Access Compliance Report

Public Rights-of-Way

Intersection ID: 10014252	Main Street: PARKWOOD_AV	Cross Street: E_17TH_ST	Location: E
ADA ID: 0F1CF8B14882	Ramp Type: PerpDiag	Initial Pass/Fail: Fail	Overall Compliance: No
		Severity Score: 12.5

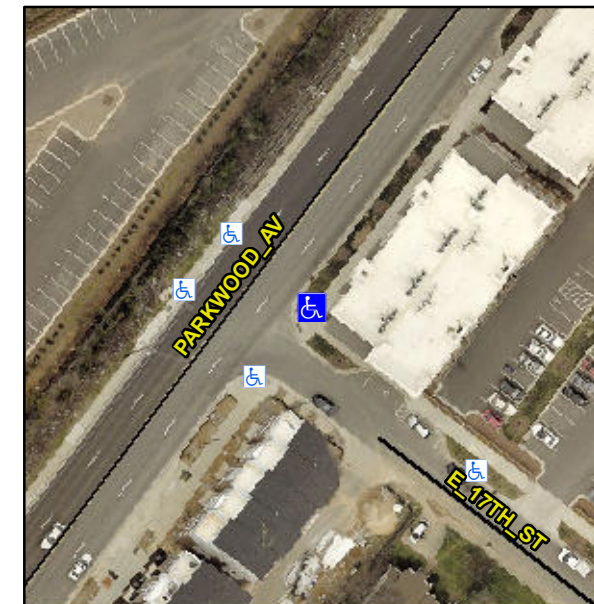
R304.2.2

Compliance	Description	Data	Compliance	Description	Data
N/A	Ramp Length (in)	97.0	No	Ramp Slope (%)	9.7
Yes	Ramp Width (in)	60.0	Yes	Ramp XSlope (%)	0.9
N/A	Flare Type LT	N/A	N/A	Flare Type RT	N/A
N/A	Flare Slope LT (%)	N/A	N/A	Flare Slope RT (%)	N/A
N/A	Flare Traversable LT?	N/A	N/A	Flare Traversable RT?	N/A
N/A	Landing Length (in)	N/A	N/A	DWS Provided?	N/A
N/A	Landing Width (in)	N/A	N/A	DWS Contrast?	N/A
N/A	Landing Slope (%)	N/A	N/A	DWS Length (in)	N/A
N/A	Landing X Slope (%)	N/A	N/A	DWS Full Width?	N/A
N/A	Landing Curb? (Y/N)	N/A	N/A	DWS Offset (in)	N/A
N/A	Shared Landing?	N/A			
N/A	Gutter Ponding?	N/A	N/A	Gutter Slope (%)	N/A
N/A	Gutter Lip Ht (in)	N/A	N/A	Gutter X Slope (%)	N/A
N/A	Painted X Walk1?	No	N/A	Painted X Walk2?	No
	X Walk 1 Direction	To NW		X Walk 2 Direction	To SW
N/A	X Walk 1 Width (in)	N/A	N/A	X Walk 2 Width (in)	N/A
	X Walk 1 Slope (%)	1.6		X Walk 2 Slope (%)	1.5
	X Walk 1 X Slope (%)	1.3		X Walk 2 X Slope (%)	0.8

Remove & Replace Curb Ramp With Two New Directional Ramps or Equivalent.
